LAUREL CANYON SUBDIVISION

MASTER DEVELOPMENT PLAN # 761A

Re: Laurel Canyon (Amendment) MDP # 761-A

The City Staff Development Review Committee has reviewed Laurel Canyon Master Development Plan M.D.P. # 761-A. Please find enclosed a signed copy for your files. Your plan was accepted with conditions as noted.

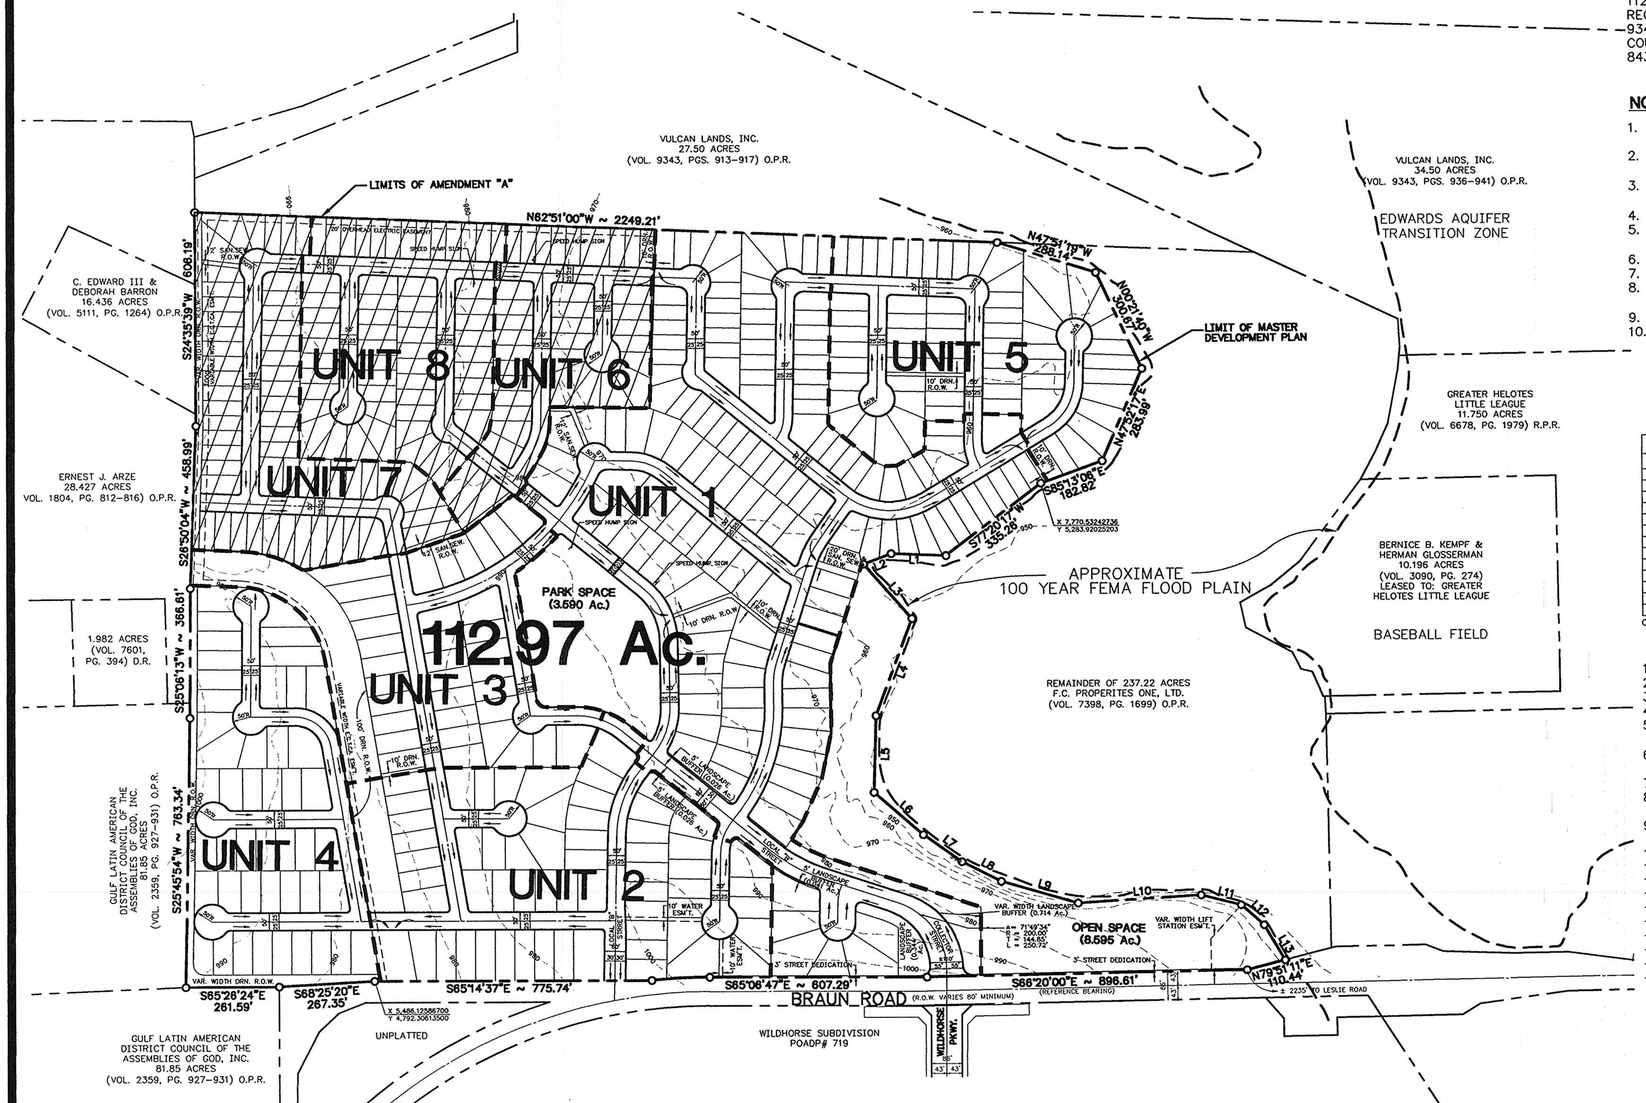
In our brief look at the plan, we saw several problems on the MDP. The liability for any damages caused by the subdivision to downstream properties and any damage caused to the subdivision itself due to drainage deficiencies, remain the sole responsibility of the developers of the property.

In our brief look at the plan, there are several concerns relating to traffic and the impact this subdivision will have on the surrounding area. Due to the deficiencies of the layout, any Traffic issues remain the sole responsibility of the developer of the property.

- In consideration of public safety and convenience, excessive grades by reason of topography should be avoided in street layouts and arrangements.

1. The 3.59-acre park designated "Park" on the plan be deeded to the Laurel Canyon Home Owner's Association (HOA). All requirements of 35-503(f)(2) are in force and required for this park.

2. Trees shall be planted parallel to all perimeter rights-of-ways. The distance between trees shall be an average of 32.5 feet with no distance greater than 50 feet. Each tree must have a minimum caliper of three (3) inches. Applicant may plant a minimum of two of the following species: Cedar Elm, Live Oak, or Monterrey Oak. Trees must be cared for and maintained by the developer for a minimum of one year.

3. The applicant shall install eight (8) picnic units and eight (8) park benches in the Park. Each unit must consist of a picnic table, benches, cement slab, and garbage receptacle. Tables and benches must be concrete or metal.

4. The applicant shall install an Open Play Area. This area is to be a minimum of 20,000 square feet of contiguous, unobstructed space with a maximum slope of five (5) percent. Common Bermuda shall be established in this area. The width of the play area must me a minimum of 100 feet.

5. The applicant shall install utilities to include security lighting and either irrigation for the care of the trees or a water fountain.

6. The applicant has requested and will receive 1.50 acres credit for the installation of a jogging trail with a minimum length of 0.25 mile meeting the requirements of Table 503-4.

7. Park to be constructed and improved with the development of Phase 1 of the subdivision.

1. For streets 1200' feet or longer, traffic calming is required.
